Subject: Revised Major Development Permit No. 010 – BC Hydro

1363 Aster Street

The purpose of this memo is to allow the Advisory Design Review Commission (ADRC) to review the revised landscape plan, lighting plan and three-dimensional images of the proposed upgraded Field Office/Works Yard.

Figure B – View from Aster Street (southwest)

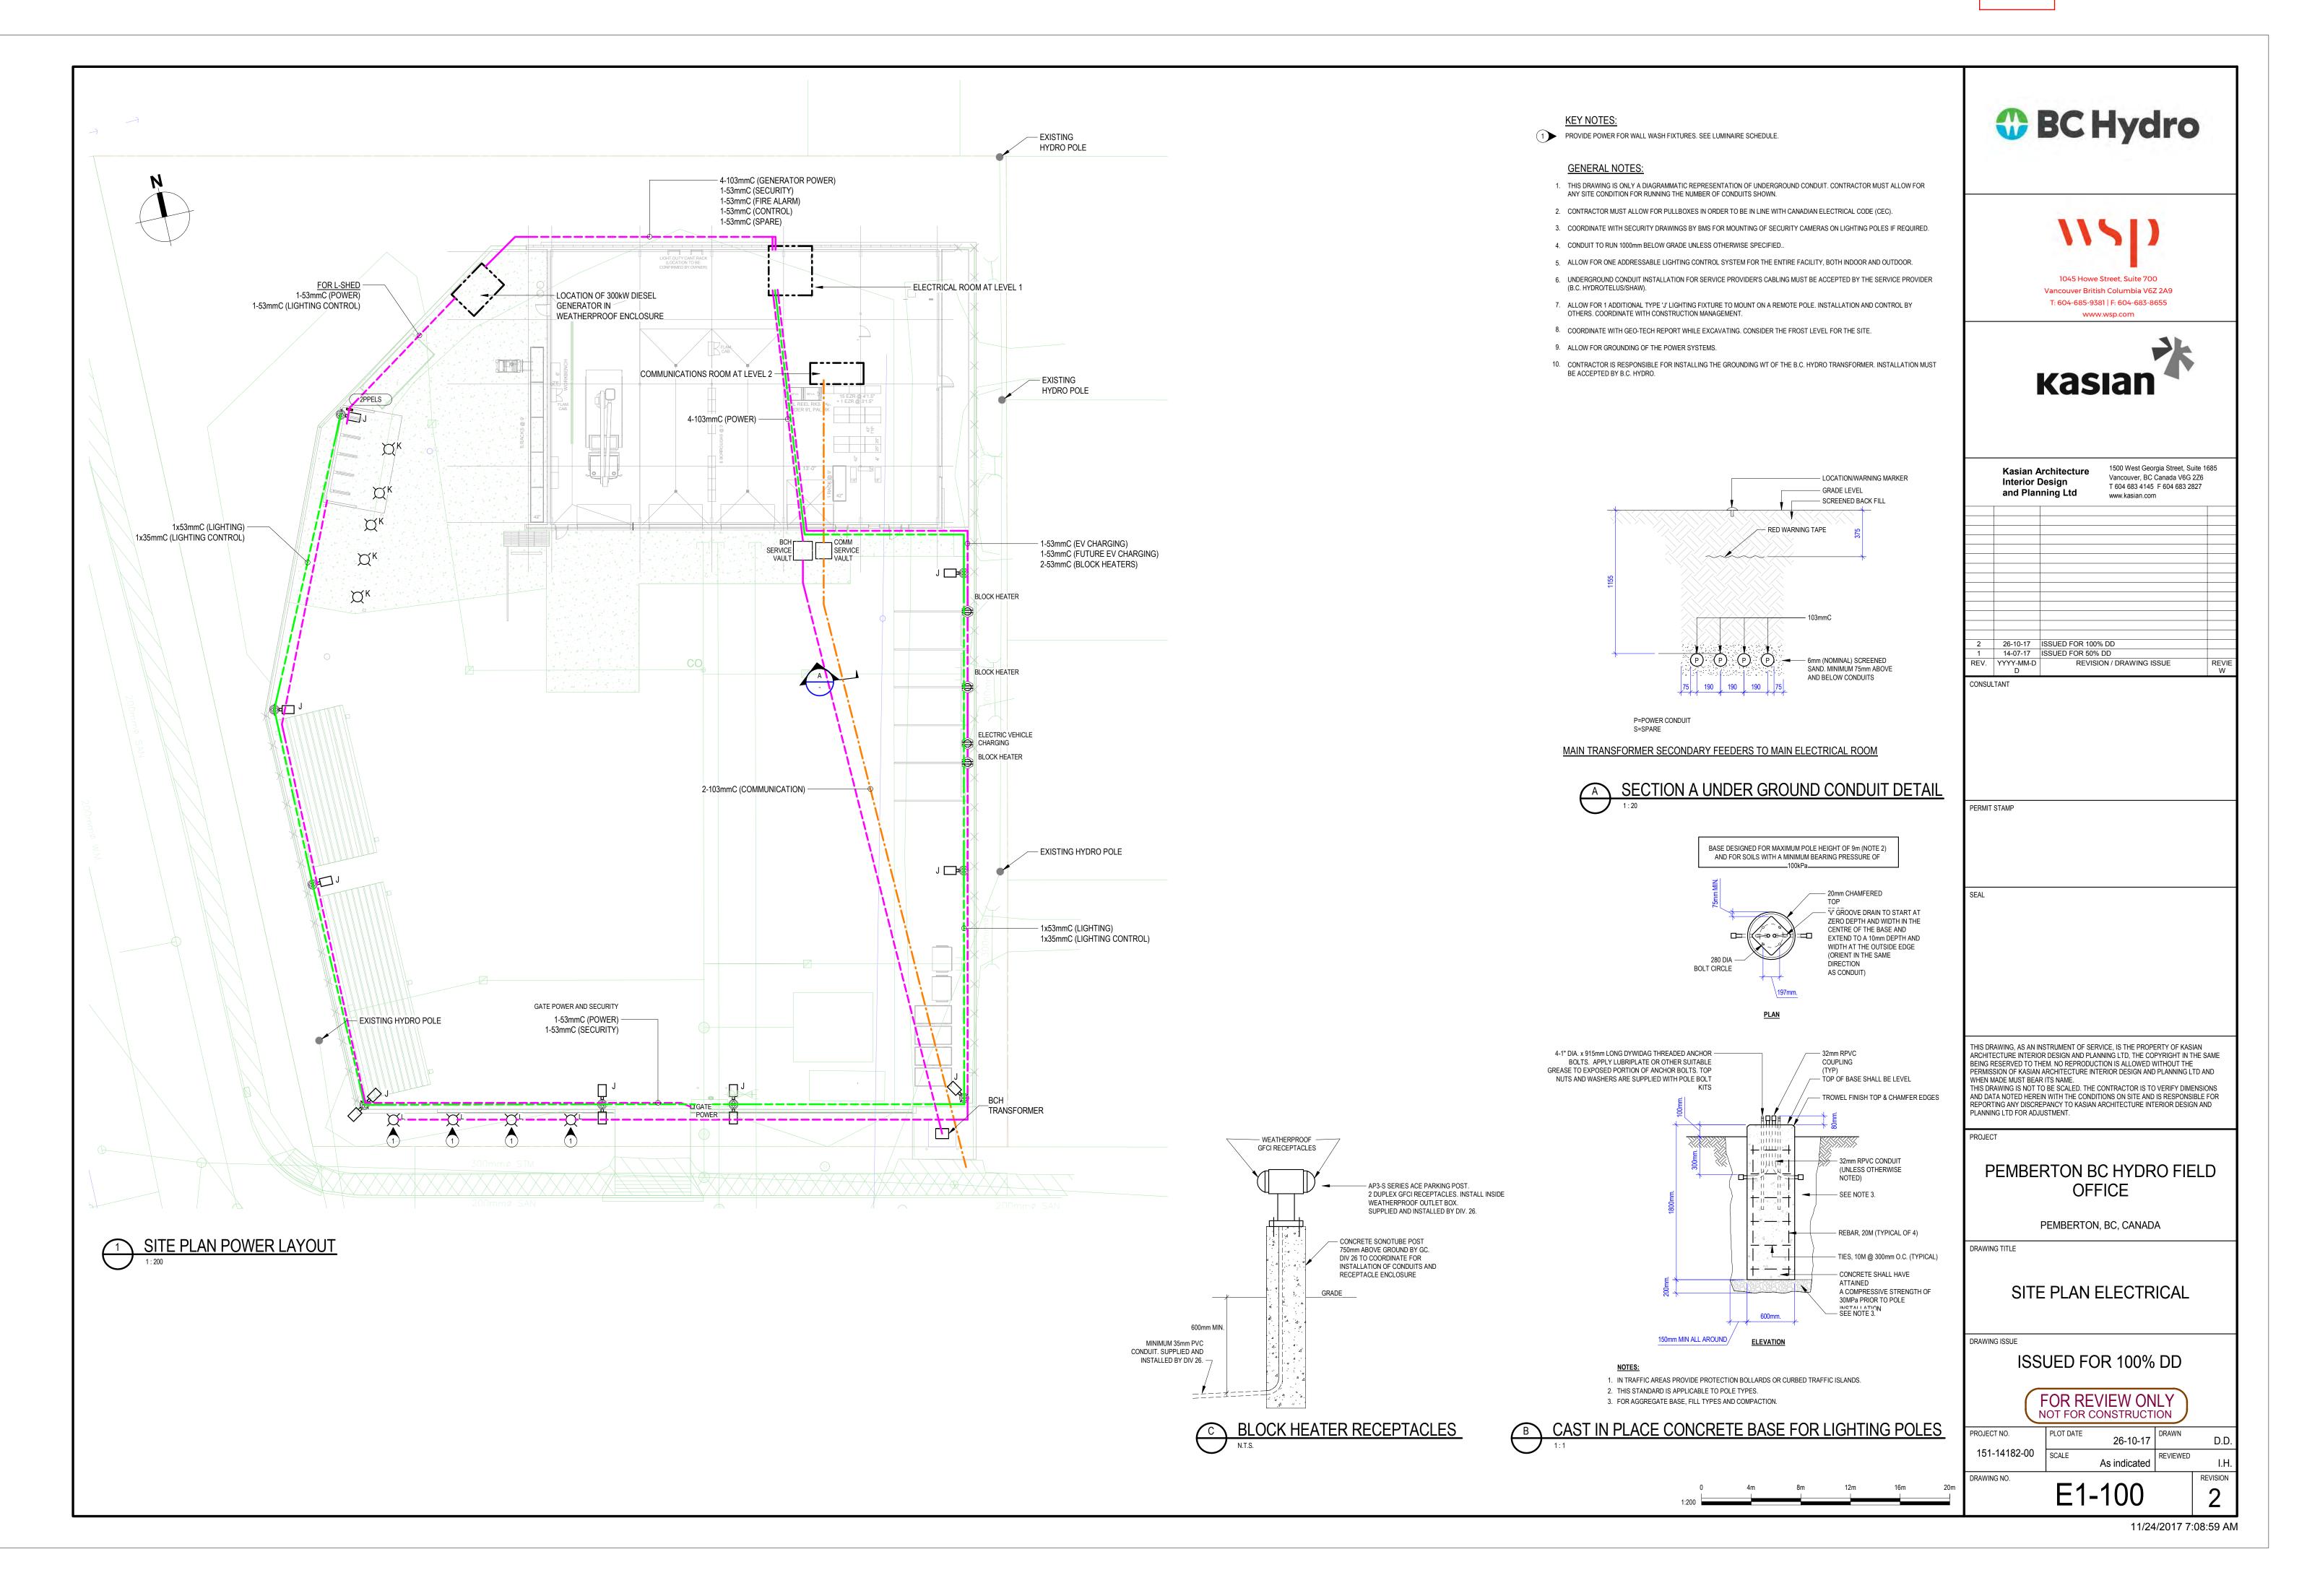
Appendix C shows various conceptual renderings of the project from different angles on Aster Street; the southwest view has been included below in Figure B.
